NO.	DATE	REVISION	APPR.
SUBMITTED	B.P.R.		
PROJECT CO-ORDINATOR			
APPROVED	C. C. Rainey		
CHIEF-DIVISION OF ACID MINE DRAINAGE ABATEMENT			
APPROVED	Robert J. [Signature]		
DIRECTOR-BUREAU OF ABANDONED MINE RECLAMATION			
COMMONWEALTH OF PENNSYLVANIA DEPARTMENT OF ENVIRONMENTAL RESOURCES OFFICE OF RESOURCES MANAGEMENT			
CONTRACT NO. BF 81-101.1			
BOND FORFEITURE RECLAMATION PROJECT NORTHWEST MINING COMPANY INC. MINING PERMIT NO. AN 81-7(C)			
CITY OF CARBONDALE		LACKAWANNA CO., PA.	
PLAN			
DRAWN BY	L.W.G.	DATE	8-15-86
CHECKED BY	D.A.K.	SCALE	As shown
		DRAWING NO.	3 of 5

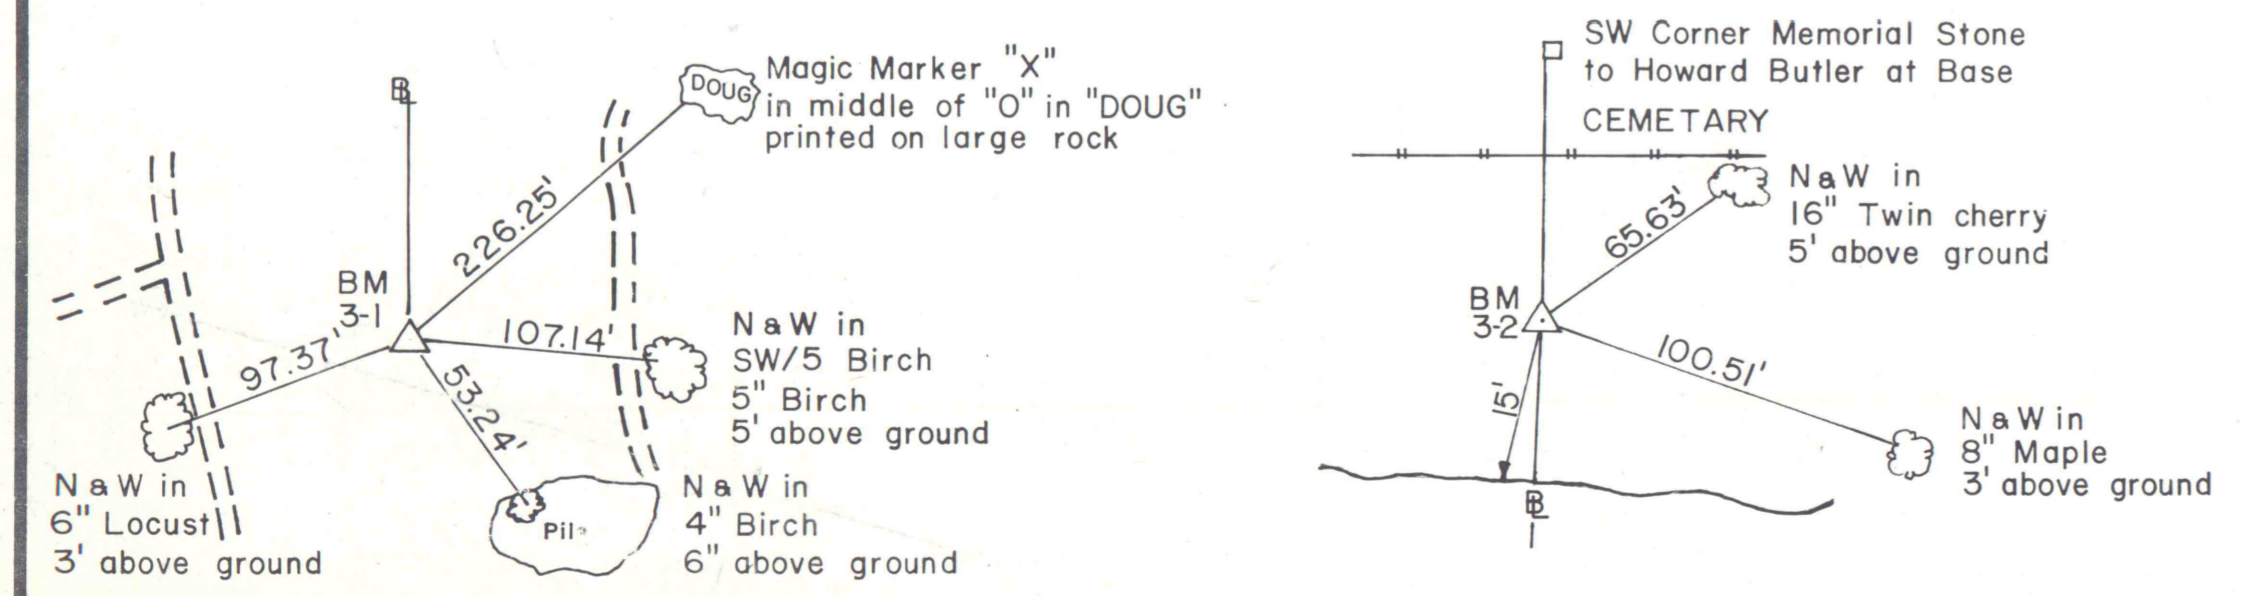
RED - DELETED WORK
GREEN - REVISED WORK
 DELETIONS AND REVISIONS ARE REQUIRED TO ELIMINATE WORK ON THE PROPERTY OF SILVERBROOK ANTHRACITE AS REQUIRED BY SILVERBROOK ANTHRACITE
